City Hall/Town Hall

December 7, 2015

Del Mar City Council

Project Status

Town Hall Terrace/Expansion B

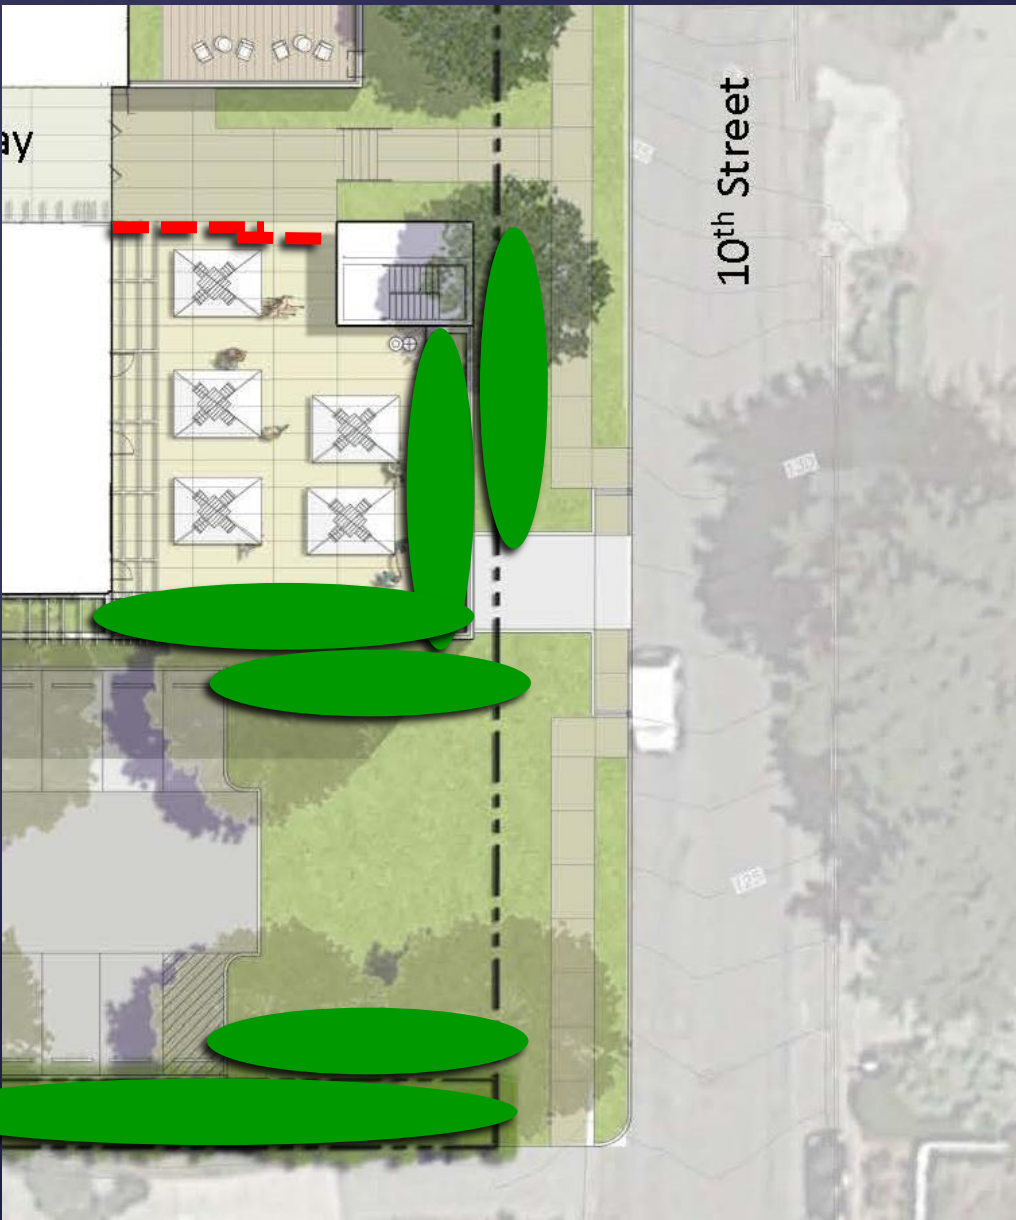
Suggested measures to provide better screening and privacy

1. Additional Screen Planting along edge and at parking structure
2. Add gate to limit access

① SITE SECTION
1" = 20'-0"

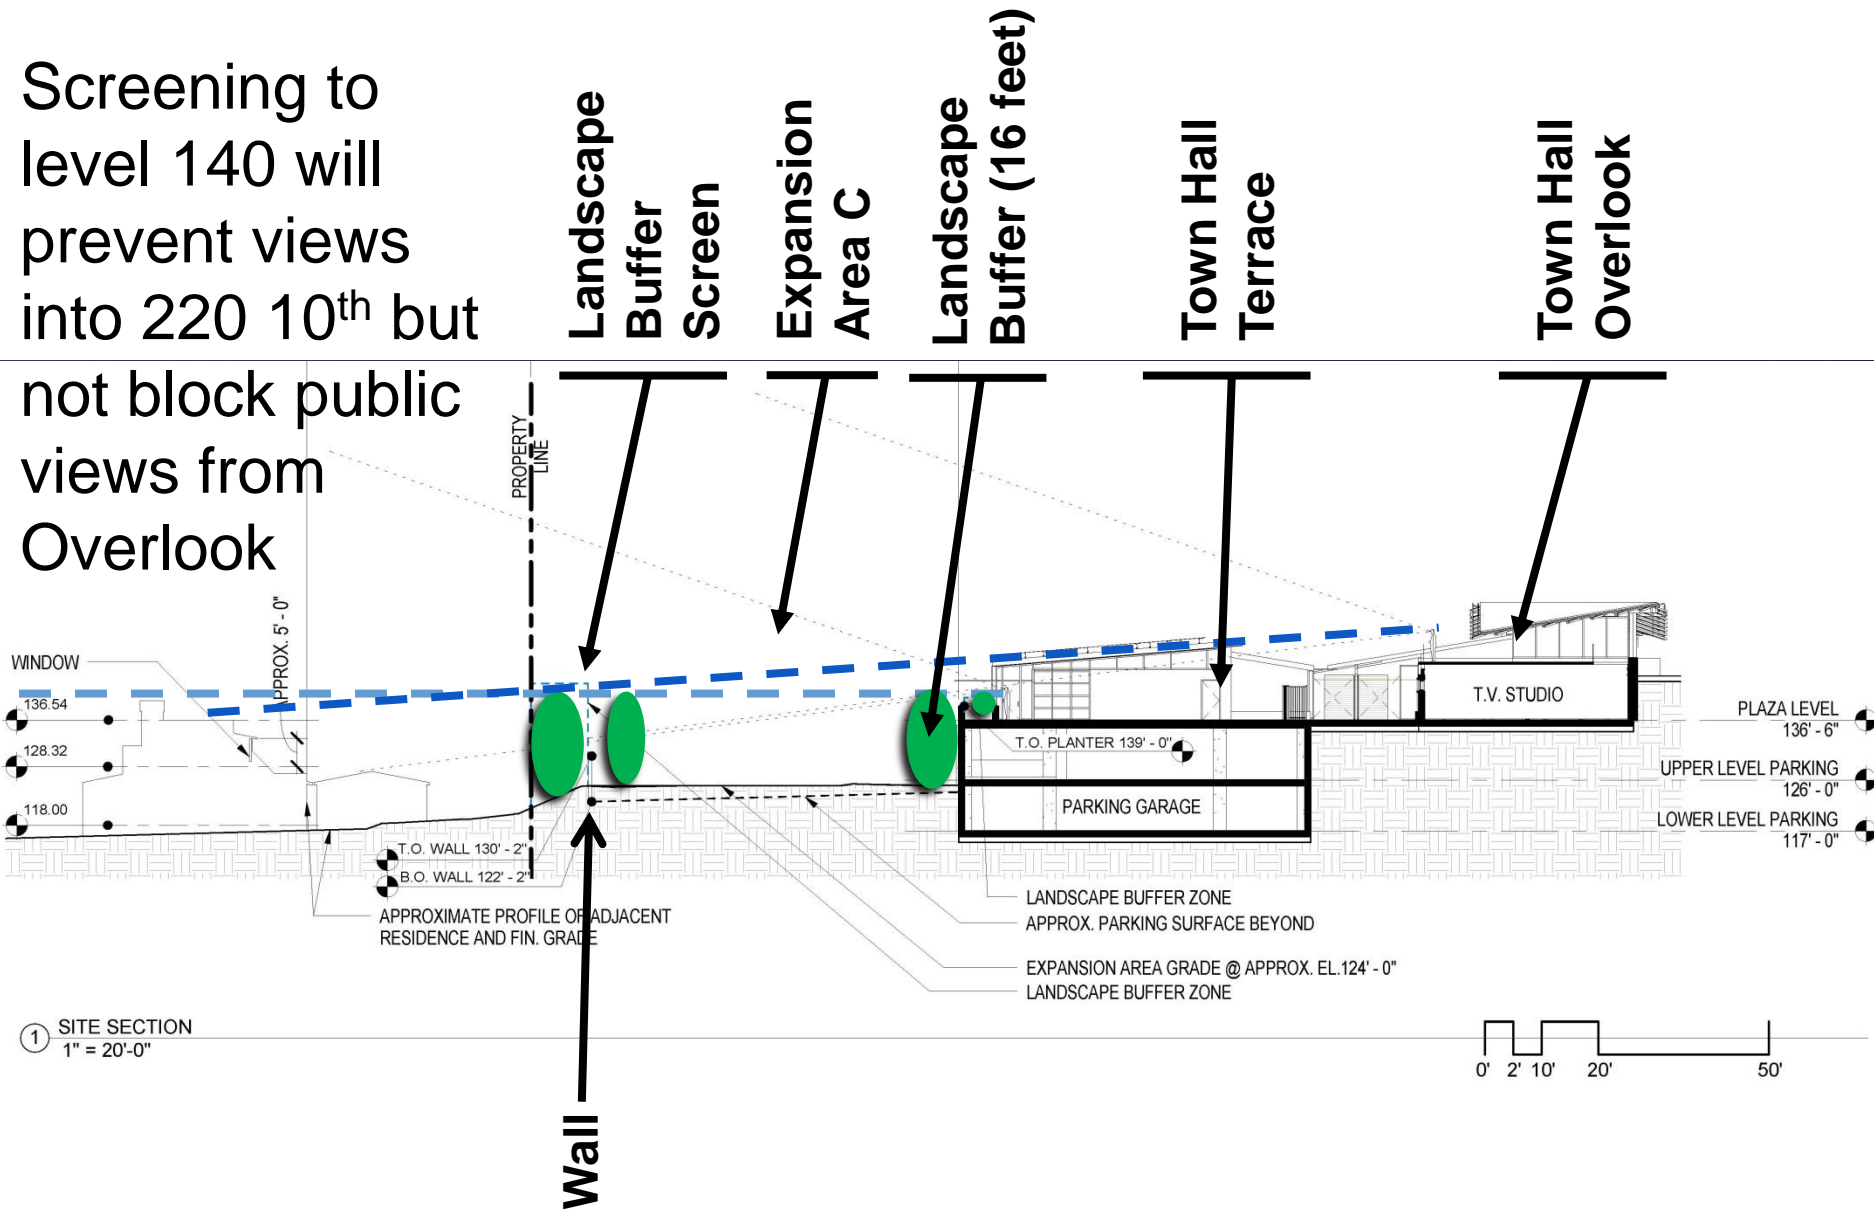
Screening to level 140 will prevent views into 220 10th but not block public views from Overlook

Town Hall Terrace/Expansion B

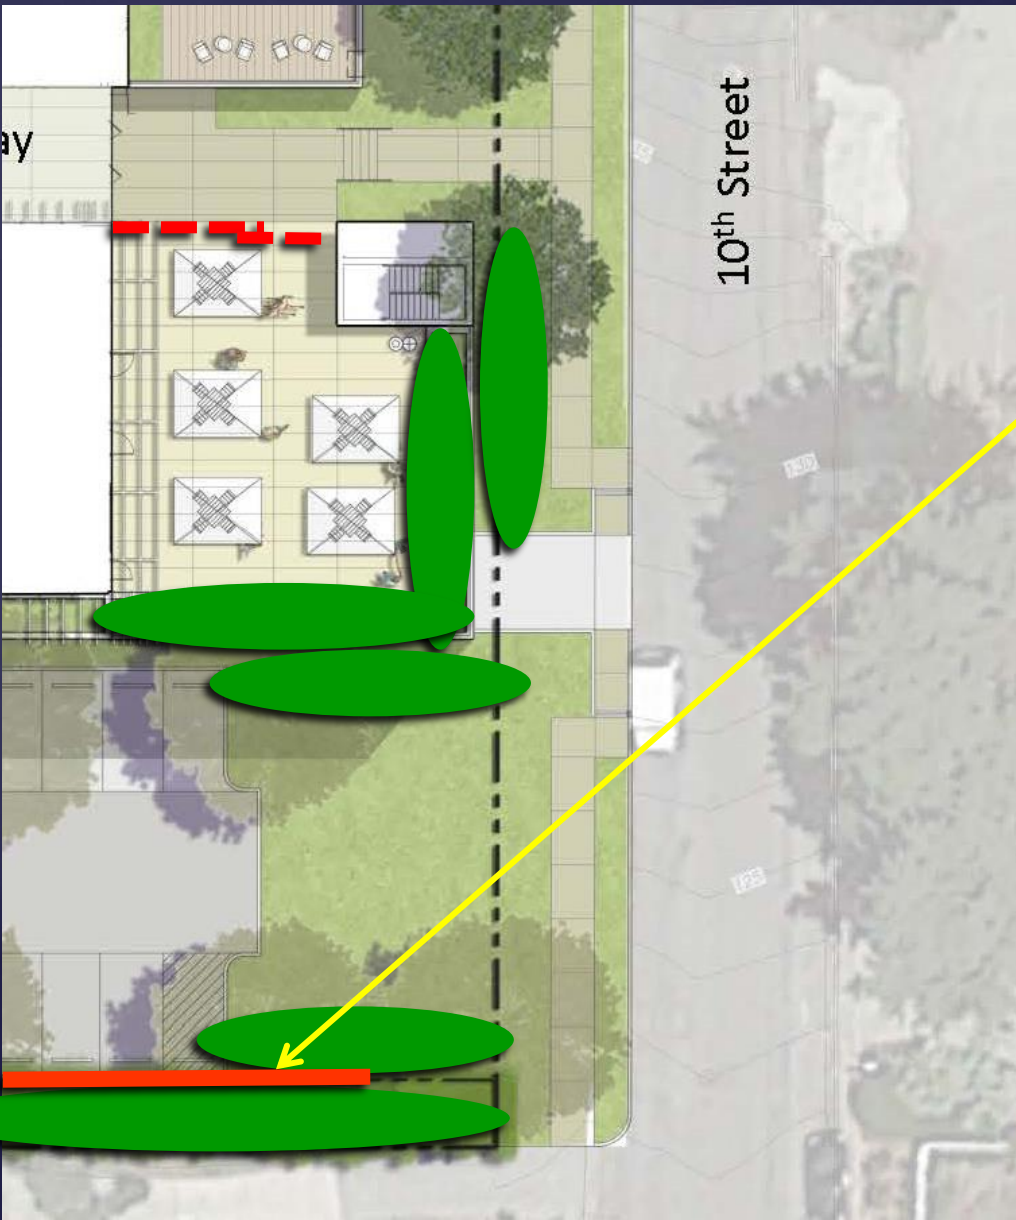
1. Additional Screen Planting along edge and at parking structure
2. Add gate to limit access
3. Extend wall to corresponding residential front yard setback; make wall 10-feet tall

Town Hall Terrace/Expansion B

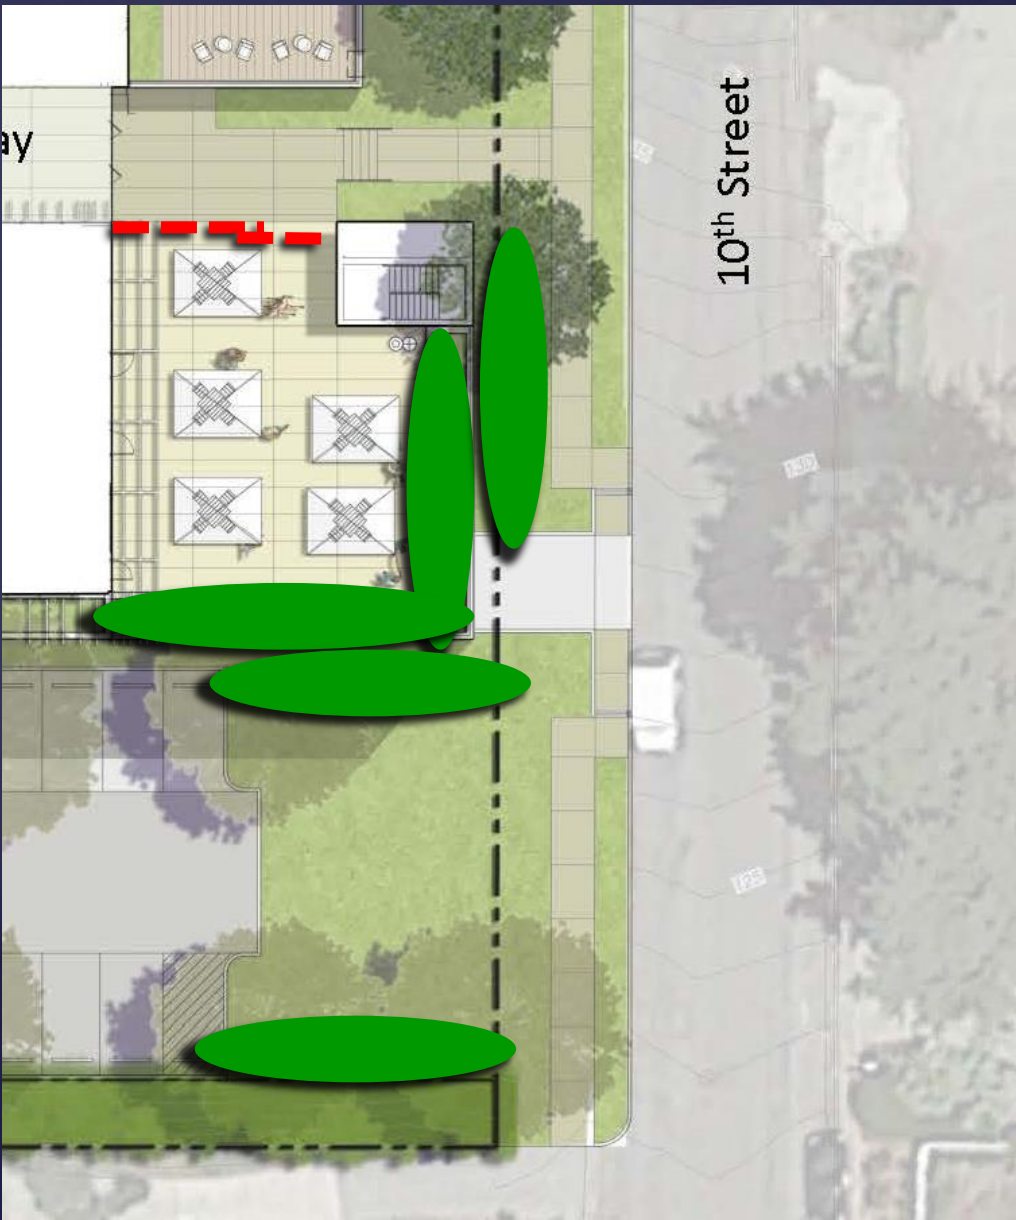
1. Additional Screen Planting along edge and at parking structure
2. Add gate to limit access
3. Extend wall; make wall 10-feet tall
4. Reduce useable size by approximately 50% to keep away from southwest corner

Town Hall Terrace/Expansion B

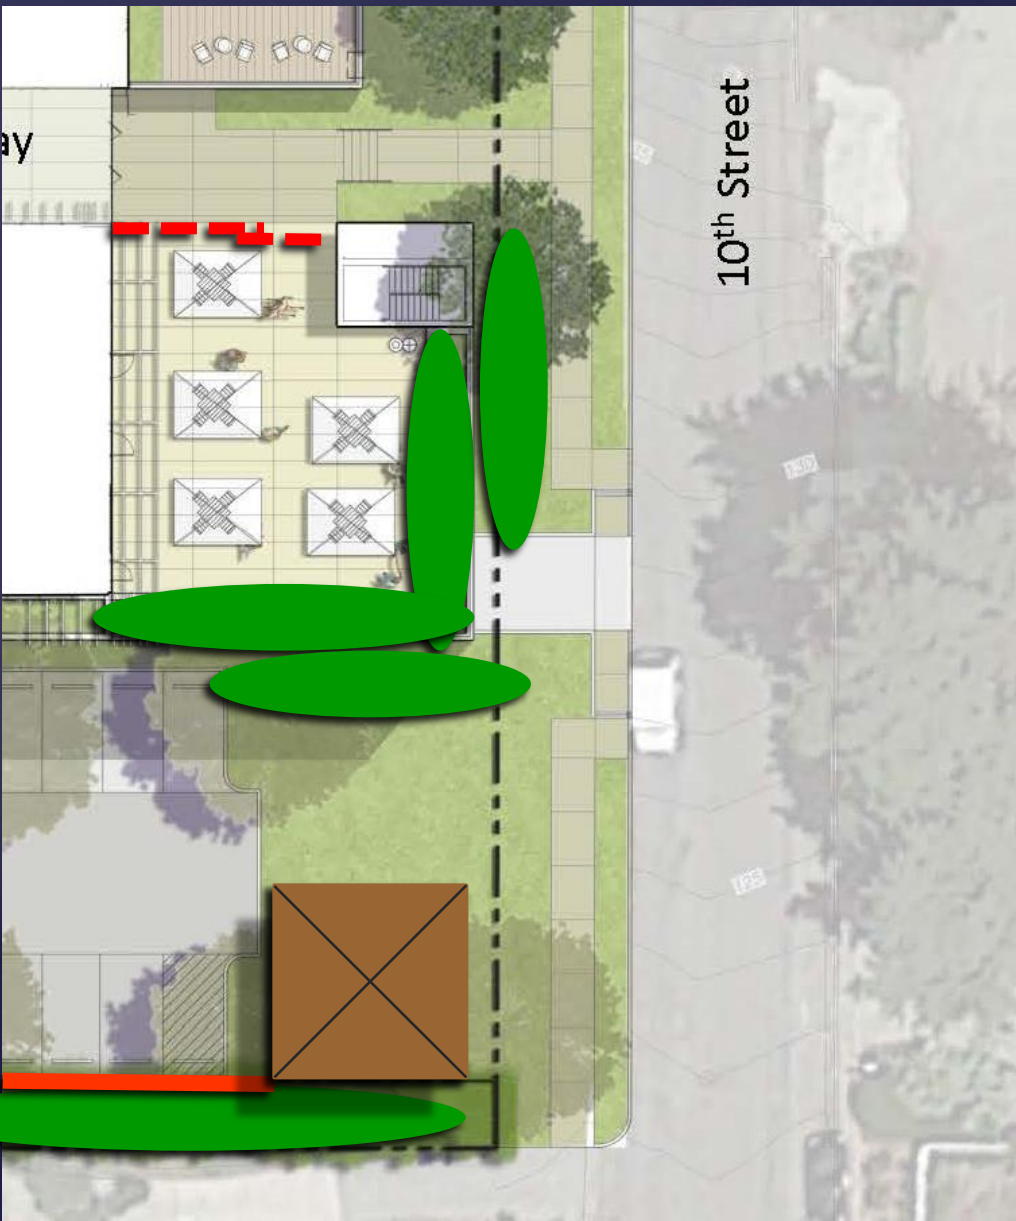
1. Additional Screen Planting along edge and at parking structure
2. Add gate to limit access
3. Extend wall; make wall 10-feet tall
4. Reduce useable size
5. Do not use except as walkway
6. Limit use of Terrace
7. Alvarado House in Expansion C to increase privacy.

Expansion Area C

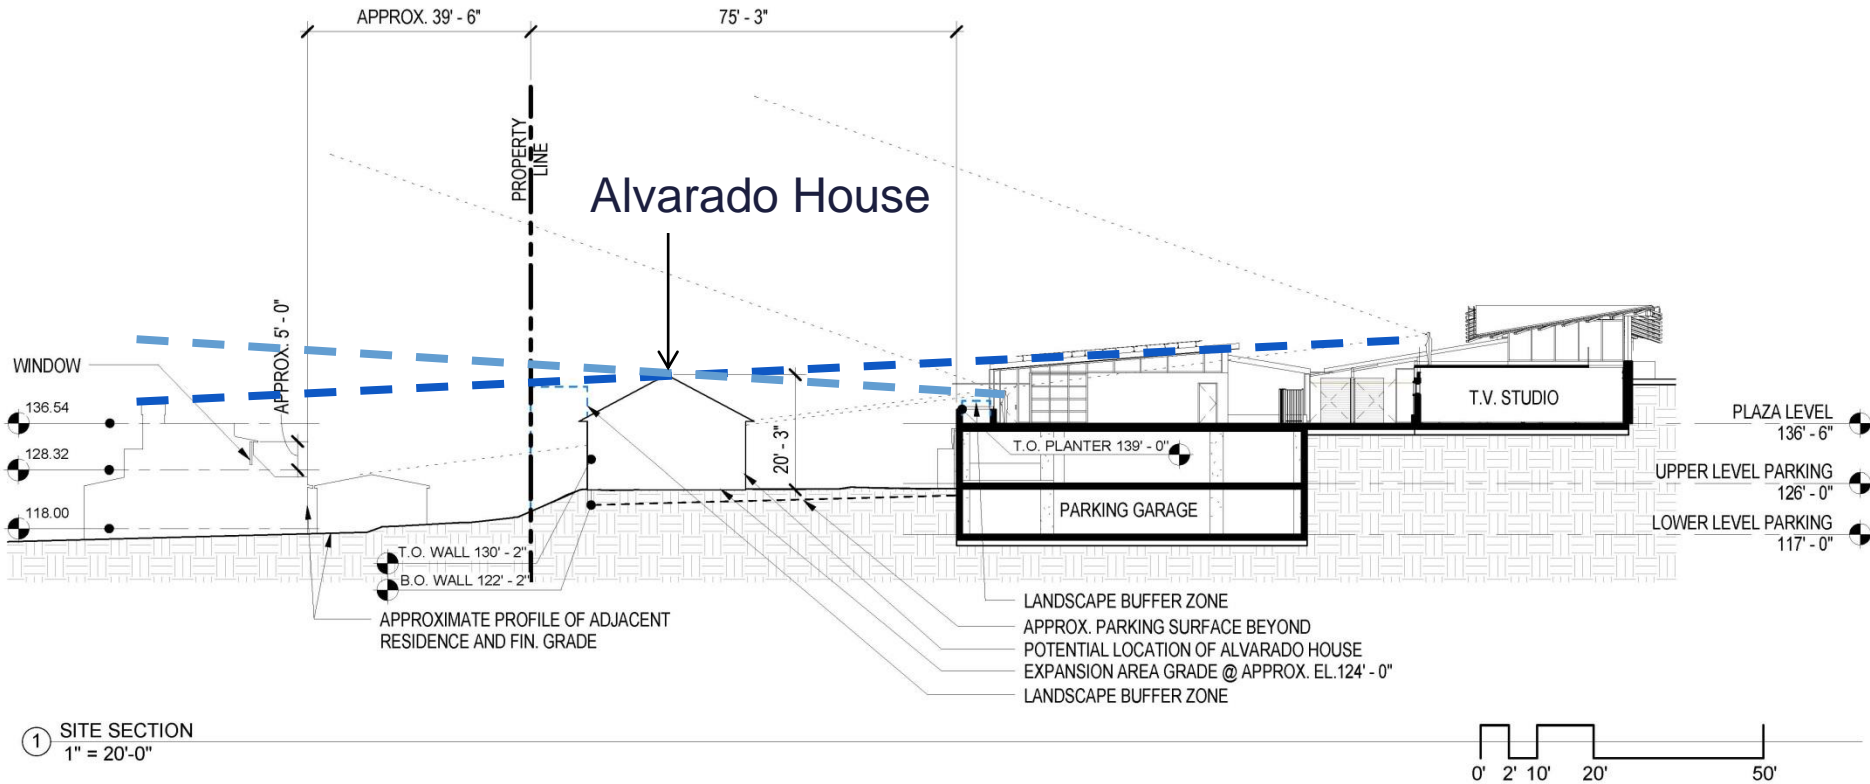
1. Additional Screen Planting along edge of wall
2. Residential front yard style landscape
3. Raise wall to 10-feet tall
4. Locate Alvarado House in Expansion Area C for privacy screen

Quantity of Parking

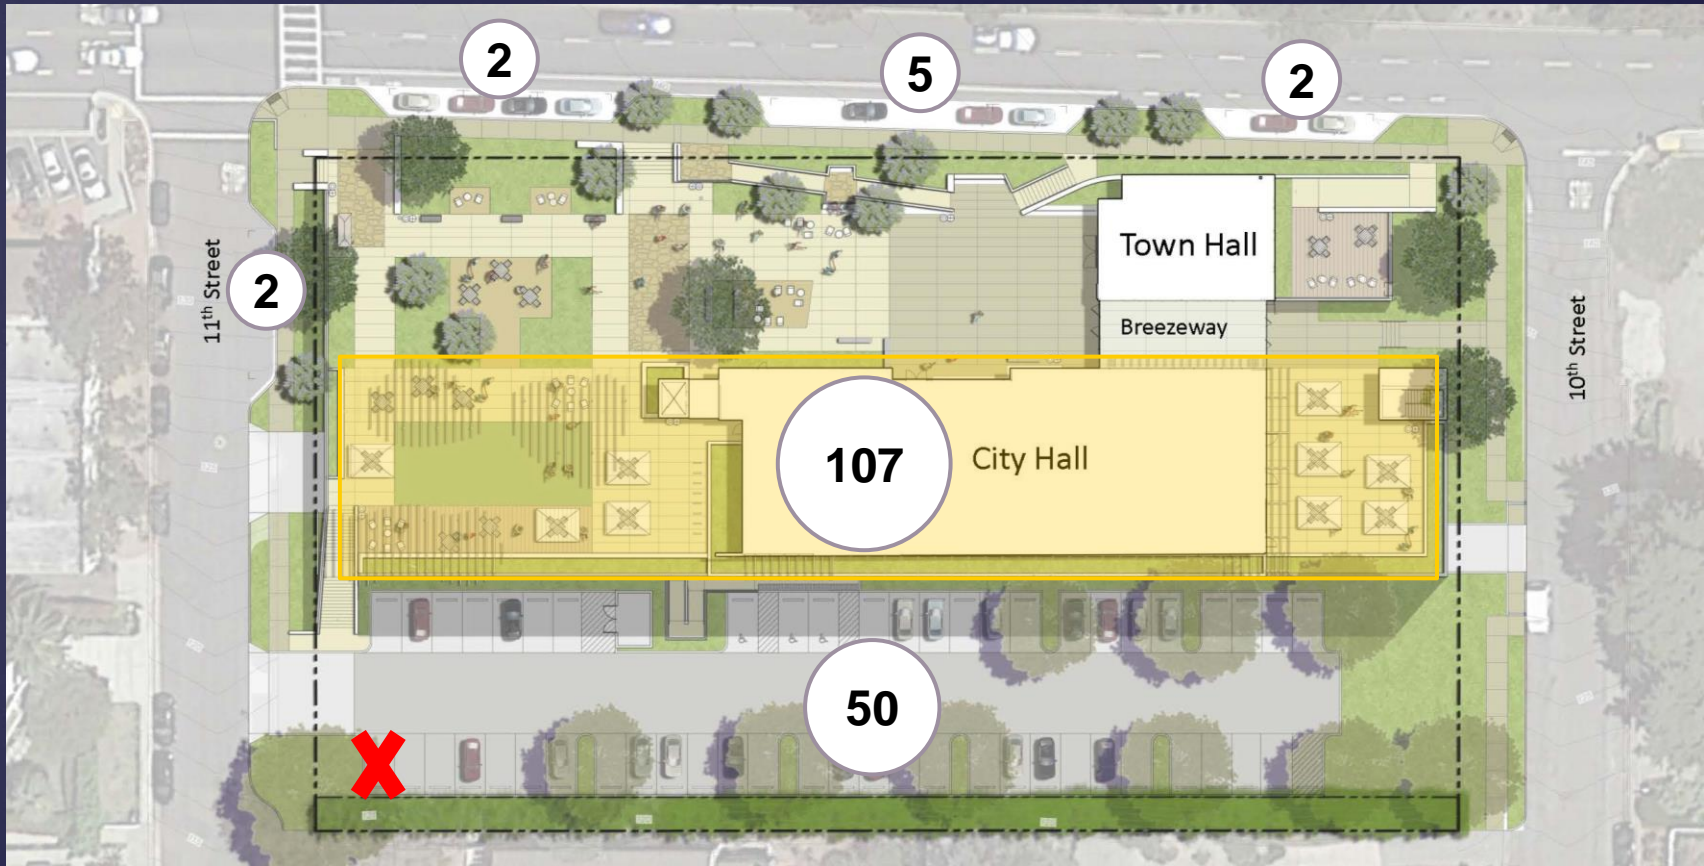
1. Allow flexibility in goal of 160 stalls; aim for 140 to 160
 - a) Eliminate 1 stall as requested by 225 11th St.
